Written submission from Ottawa Riverkeeper

Canadian Nuclear Laboratories (CNL)

Application from the CNL to amend its Chalk River Laboratories site licence to authorize the construction of a near surface disposal facility

Comments on the Licence Amendment -
Required Approvals for Construction of the Near Surface Disposal Facility (NSDF) at the
Chalk River Laboratories (CRL) site (CMD 22-H7)

Figure 1 - Chalk River / NSDF Surface Water Monitoring Stations

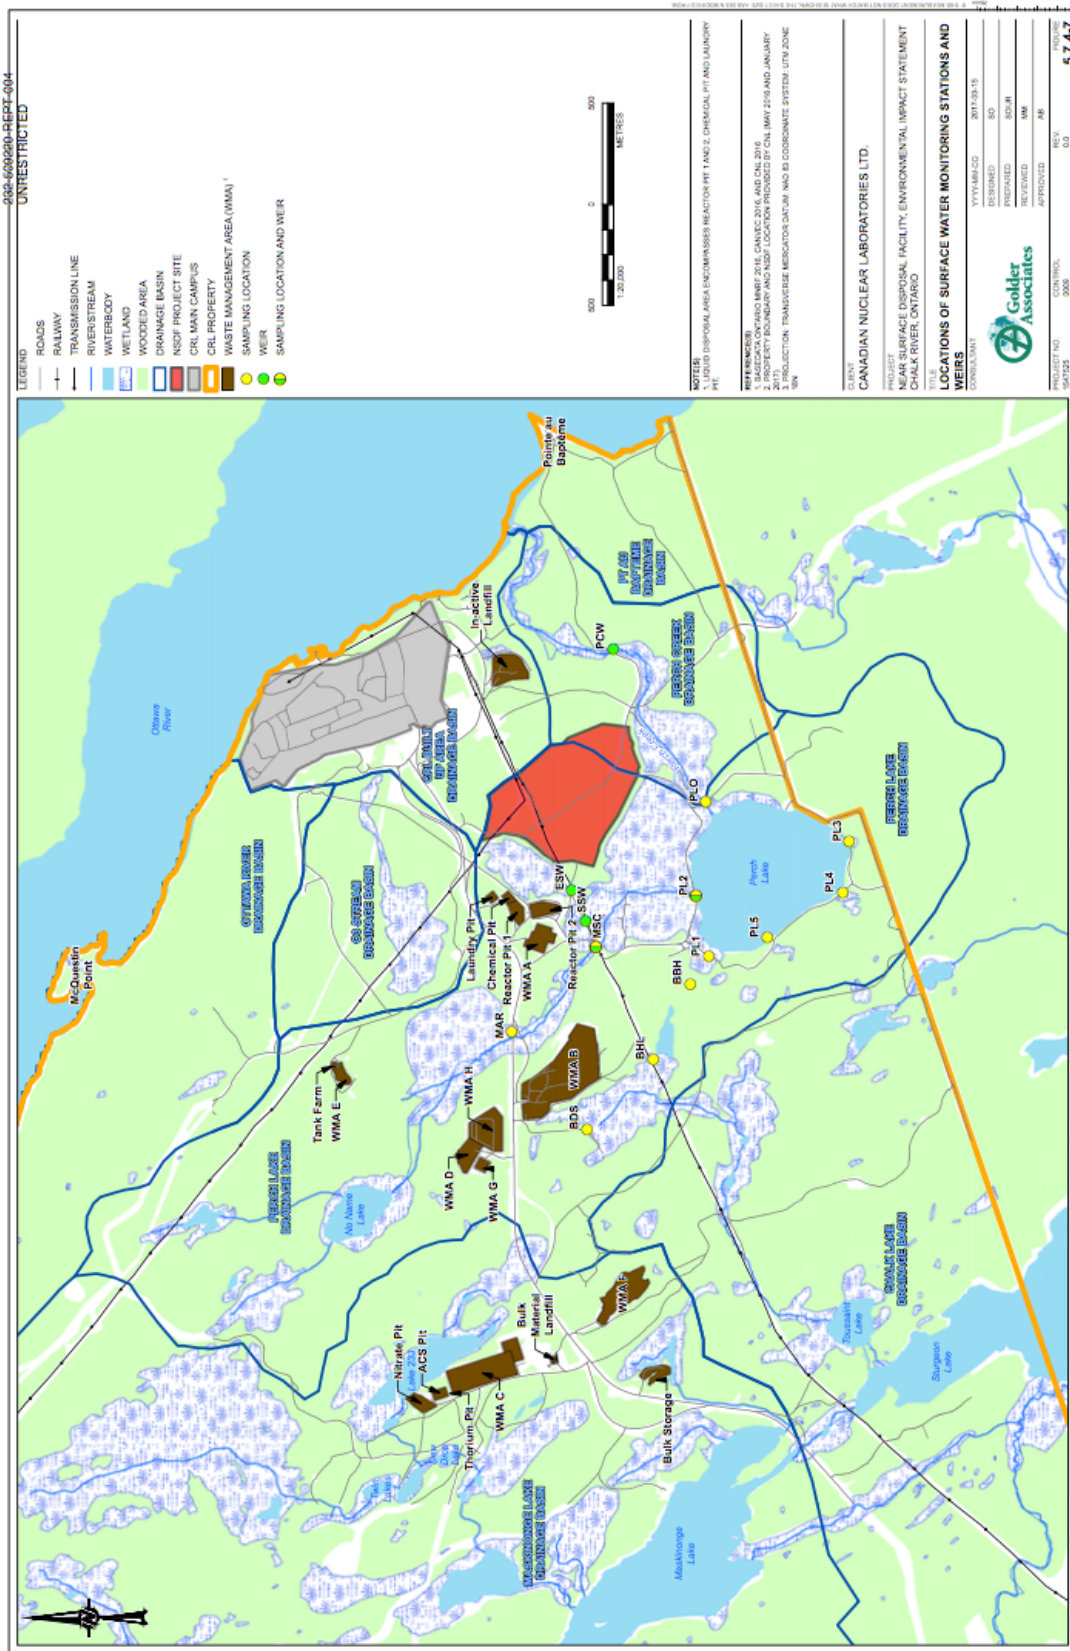
<u>Monitoring Locations</u> (see Figure 1 map on next page)	<u>Tritium Levels</u>	<u>Reference</u>
Background Tritium Levels in Undeveloped NSDF area	48 to 399 Bq/L	Tables 5.3.2-5 and 5.3.2-6
Tritium Levels in Groundwater in East Swamp WMAs	no disclosure provided in final EIS	
East Swamp Weir (ESW)	286 to 348 Bq/L	Table 5.7.4-8
Perch Lake Inlet (PL2)	1,354 to 3,249 Bq/L	Table 5.7.4-8
Perch Lake Outlet (PLO)	1,367 to 2,780 Bq/L	Table 5.7.4-8
Perch Creek - Weir (PCW)	2,056 to 4,233 Bq/L	Table 5.7.4-8

For any other parameter considered in the final EIS, the fact that background levels in the watershed are elevated would not be a concern. This is because the effluent quality discharge targets adopted in EIS Table 3.4.2-2 and Table 3.4.2-3 are based on regulatory limits for each of the parameters being considered - except tritium.
